Access Compliance Report

Public Rights-of-Way

(Curb Ramps)

Intersection ID: 29459	Main Street: N_ALEXANDER_ST	Cross Street: GARDEN_DISTRICT_DR	Location: N
ADA ID: 9174FA61FBB6	Ramp Type: PerpDiag	Initial Pass/Fail: Fail	Overall Compliance: No
		Severity Score: 22.5

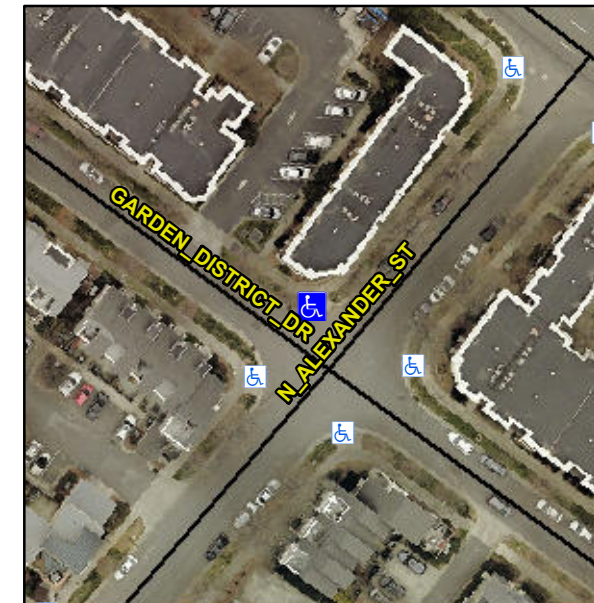
Not Found, R304.5.1, R304.2.2, R304.5.3

Compliance	Description	Data	Compliance	Description	Data
N/A	Ramp Length (in)	76.0	No	Ramp Slope (%)	10.0
No	Ramp Width (in)	42.0	No	Ramp XSlope (%)	5.0
N/A	Flare Type LT	N/A	N/A	Flare Type RT	N/A
N/A	Flare Slope LT (%)	N/A	N/A	Flare Slope RT (%)	N/A
N/A	Flare Traversable LT?	N/A	N/A	Flare Traversable RT?	N/A
N/A	Landing Length (in)	N/A	N/A	DWS Provided?	N/A
N/A	Landing Width (in)	N/A	N/A	DWS Contrast?	N/A
N/A	Landing Slope (%)	N/A	N/A	DWS Length (in)	N/A
N/A	Landing X Slope (%)	N/A	N/A	DWS Full Width?	N/A
N/A	Landing Curb? (Y/N)	N/A	N/A	DWS Offset (in)	N/A
N/A	Shared Landing?	N/A			
N/A	Gutter Ponding?	N/A	N/A	Gutter Slope (%)	N/A
N/A	Gutter Lip Ht (in)	N/A	N/A	Gutter X Slope (%)	N/A
N/A	Painted X Walk1?	No	N/A	Painted X Walk2?	No
	X Walk 1 Direction	To SW		X Walk 2 Direction	To SE
N/A	X Walk 1 Width (in)	N/A	N/A	X Walk 2 Width (in)	N/A
	X Walk 1 Slope (%)	0.2		X Walk 2 Slope (%)	1.6
	X Walk 1 X Slope (%)	3.4		X Walk 2 X Slope (%)	0.7

Remove & Replace Curb Ramp With Two New Directional Ramps or Equivalent.
